Architect's Supplemental Instructions

Wilma P. Mankiller Health Center
Expansion
Stilwell, OK

ASI Number: Bid Package 02 ASI 006

Construction Documents – ASI 06 – Wilma P. Mankiller Health Center Expansion

E3.01
ELECTRICAL SCHEDULES AND RISER

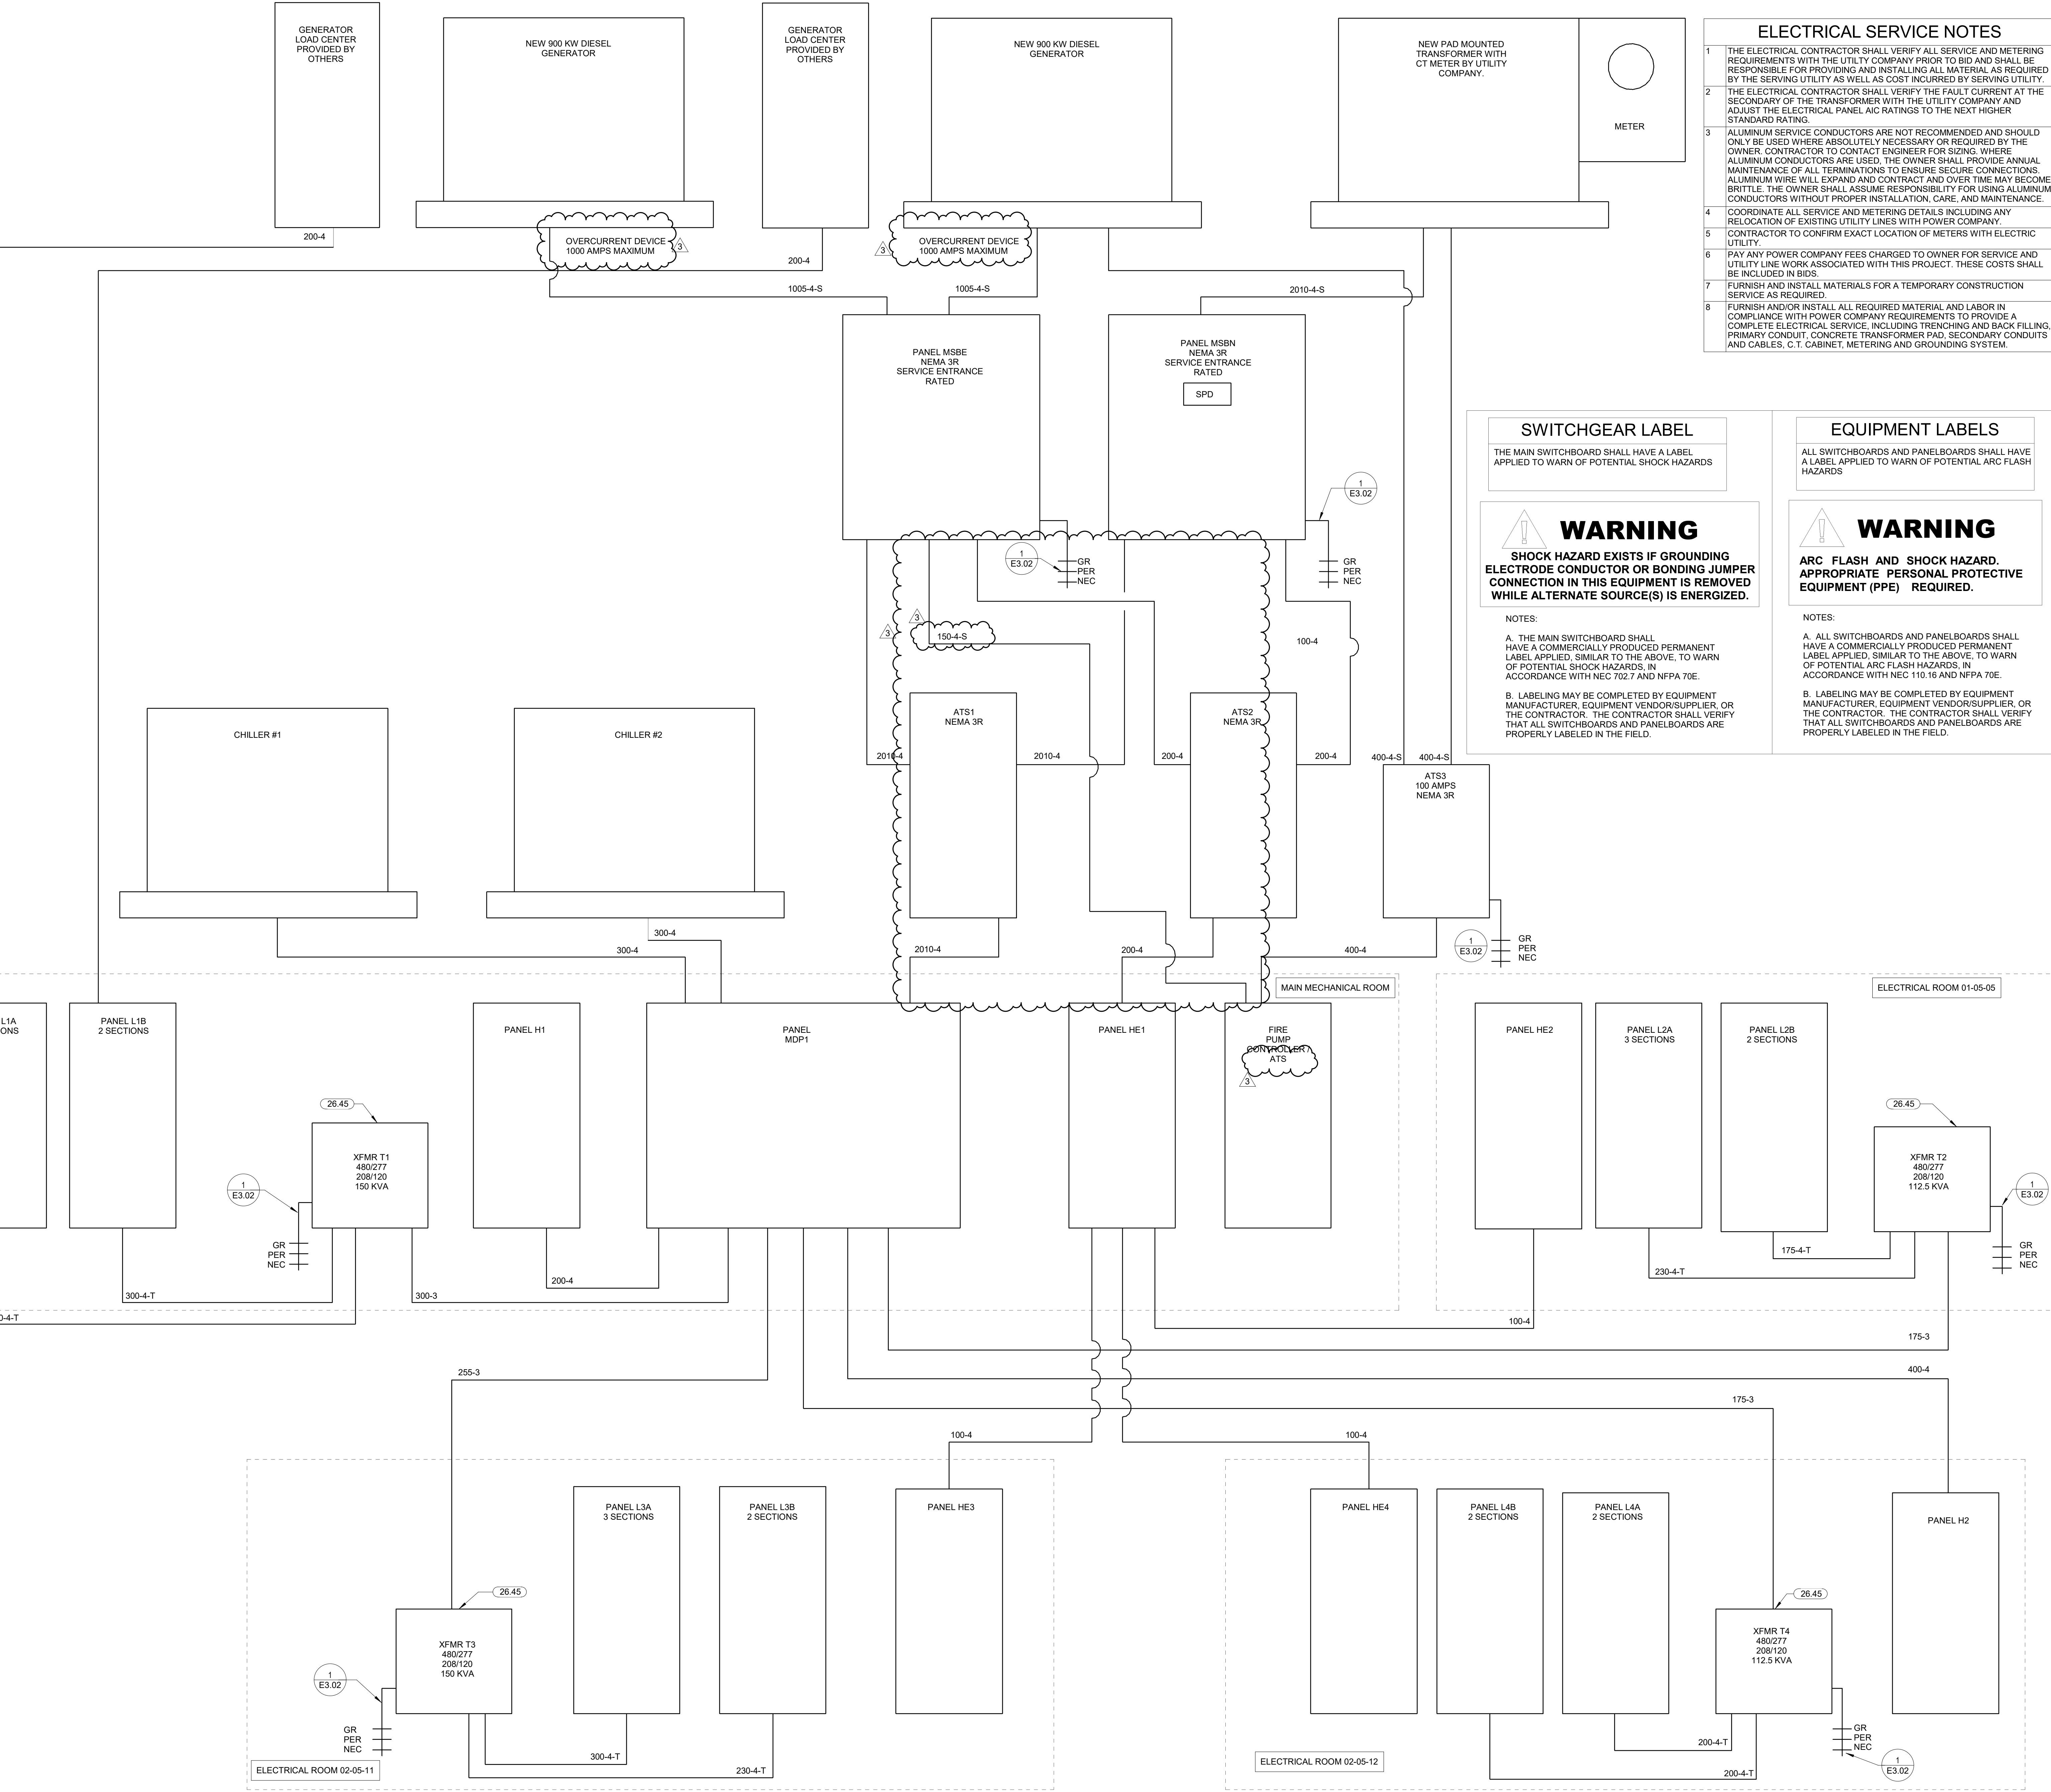
1. E3.01:
 - a. ADDED 150A 4 WIRE FEEDER TO CONNECT FIRE PUMP CONTROLLER TO MSBE
 - b. CHANGED TITLE OF FIRE PUMP CONTROLLER TO INCLUDE ATS
 - c. ADDED NOTES DENOTING 1000A OVERCURRENT MAXIMUM FOR GENERATORS
2. E3.02:
 - a. ADDED 150A BREAKER FOR FIRE PUMP TO MSBE PANEL SCHEDULE
